# FLYING HORSE NORTH FILING NO. 5

## A MINOR AMENDMENT TO THE 2016 FLYING HORSE NORTH PUD DEVELOPMENT PLAN / PRELIMINARY PLAN

PUD PRELIMINARY PLAN MINOR AMENDMENT  
COVER

PCD FILE NO.: PUDSP245  
SHEET  
TRS  
3

PUD PRELIMINARY PLAN MINOR AMENDMENT  
OVERALL SITE PLAN

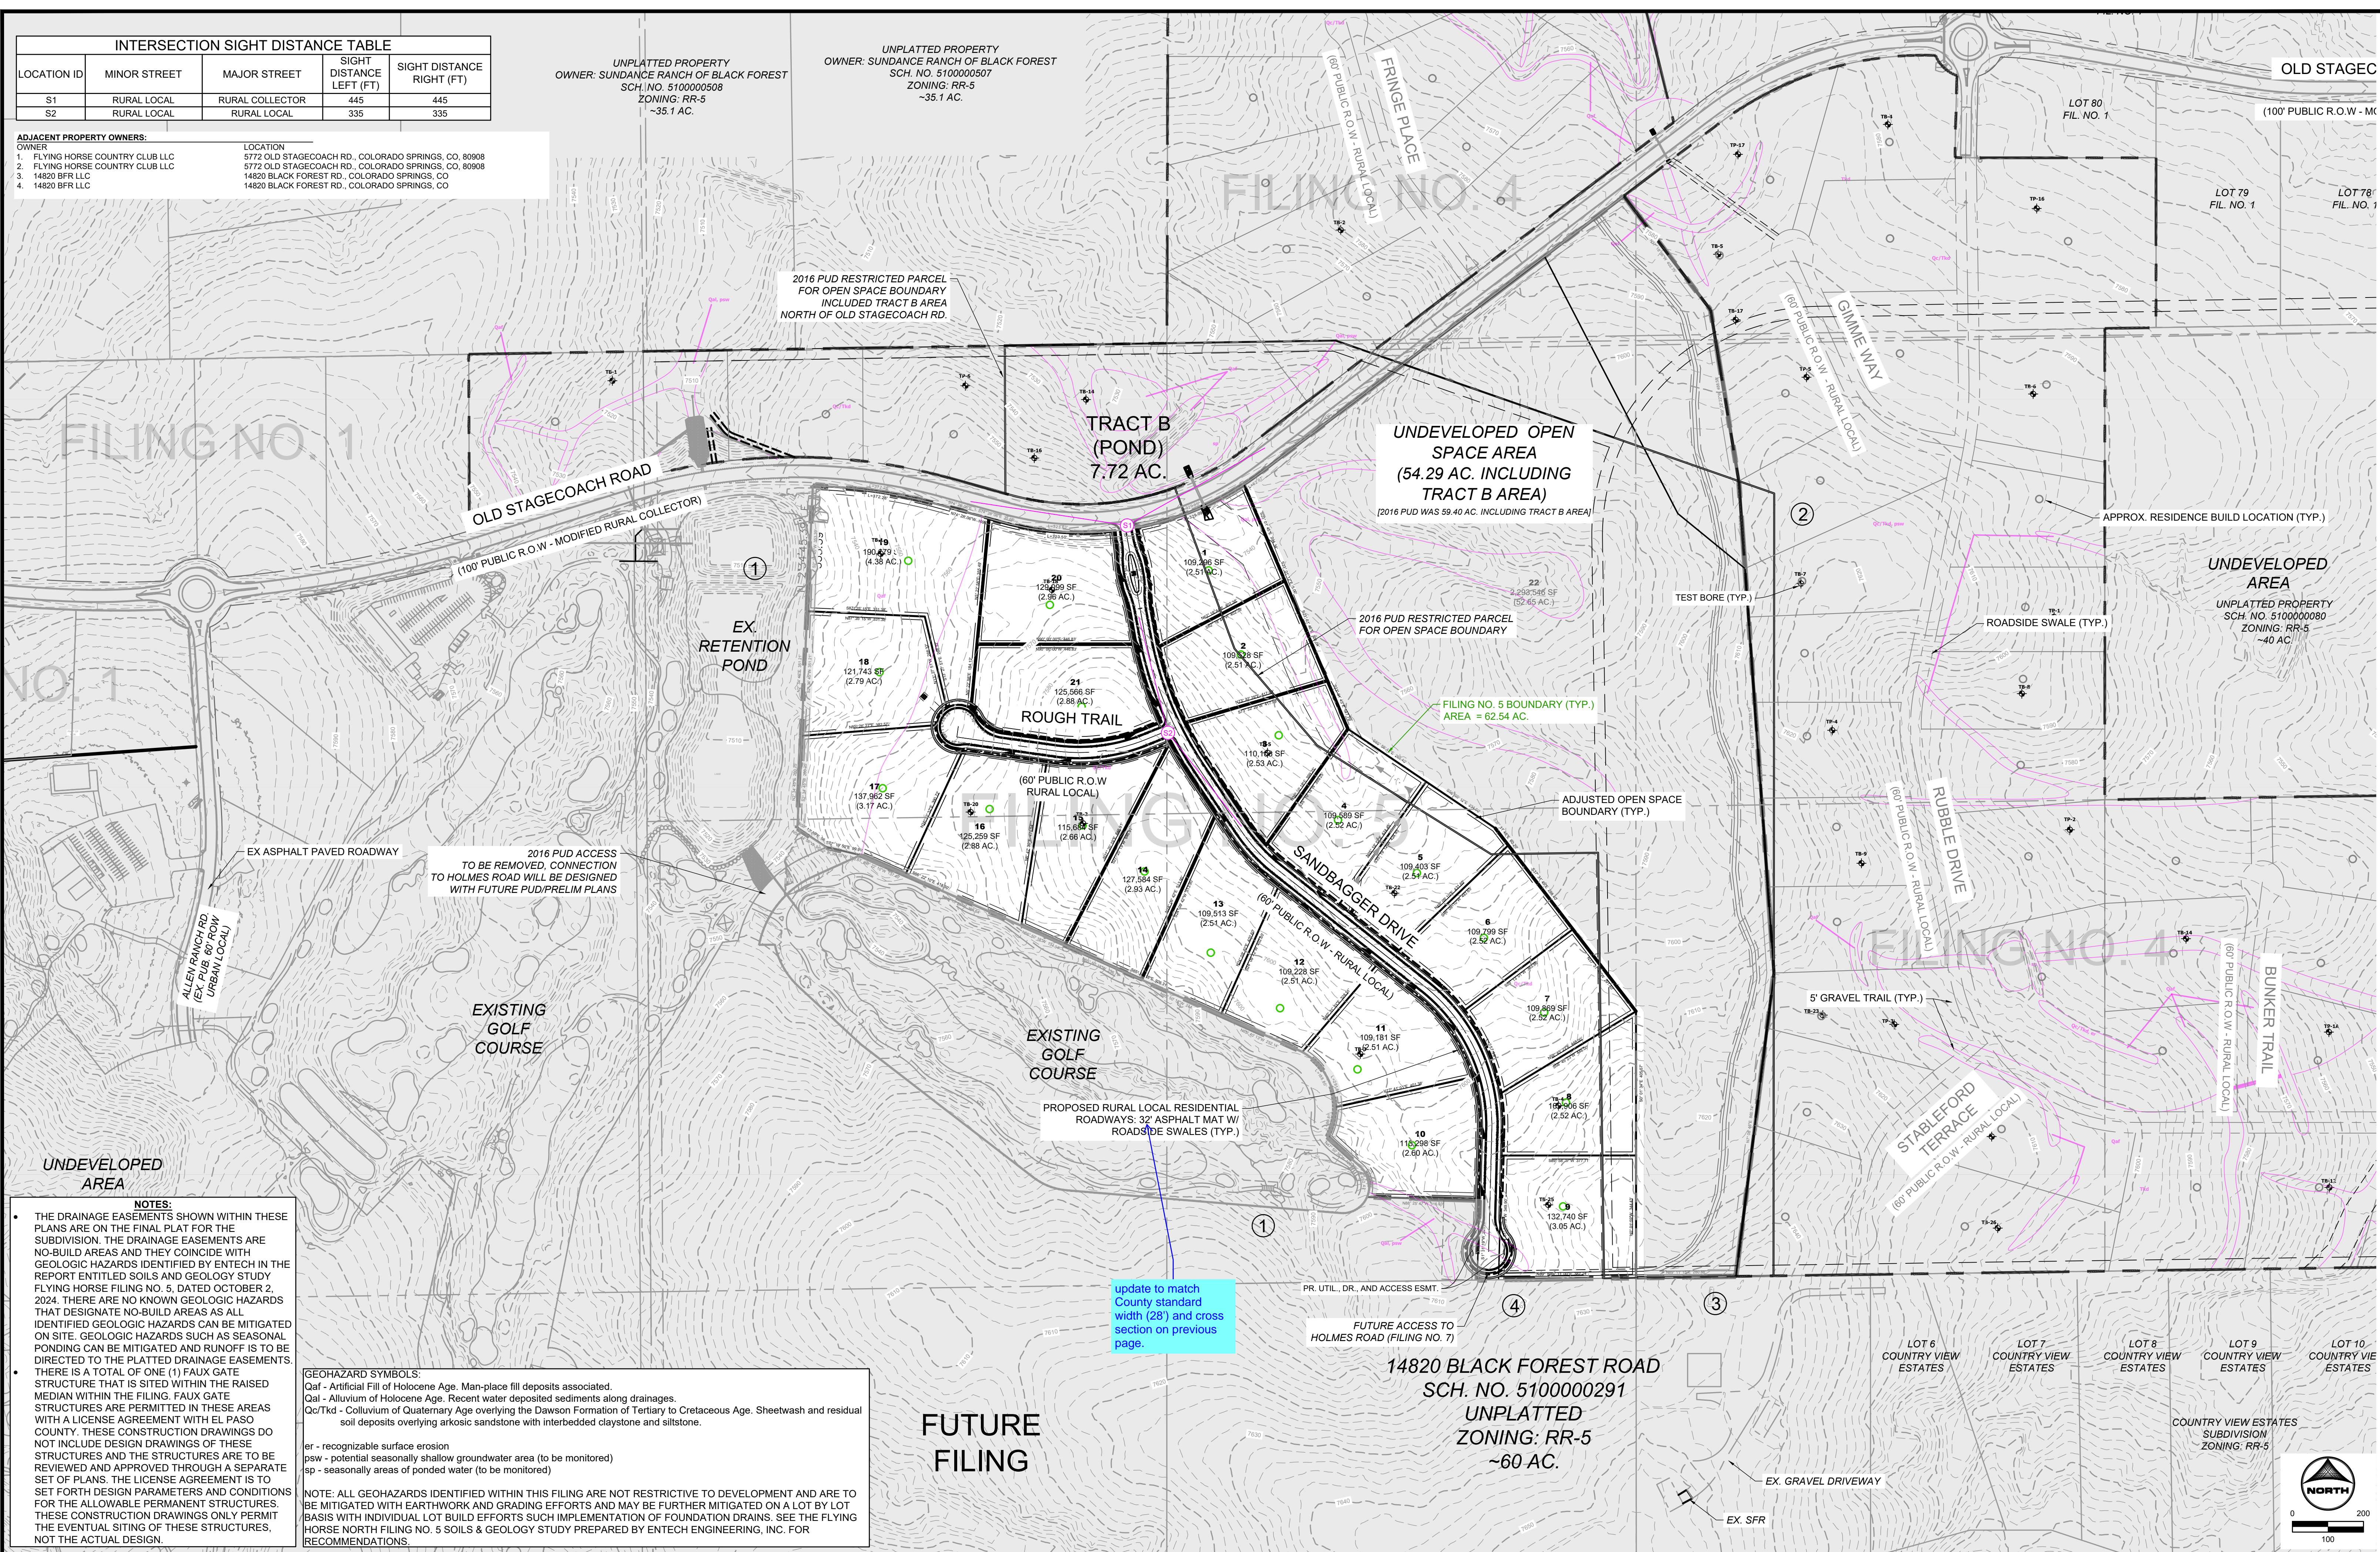
**update to match County standard width (28') and cross section on previous page.**
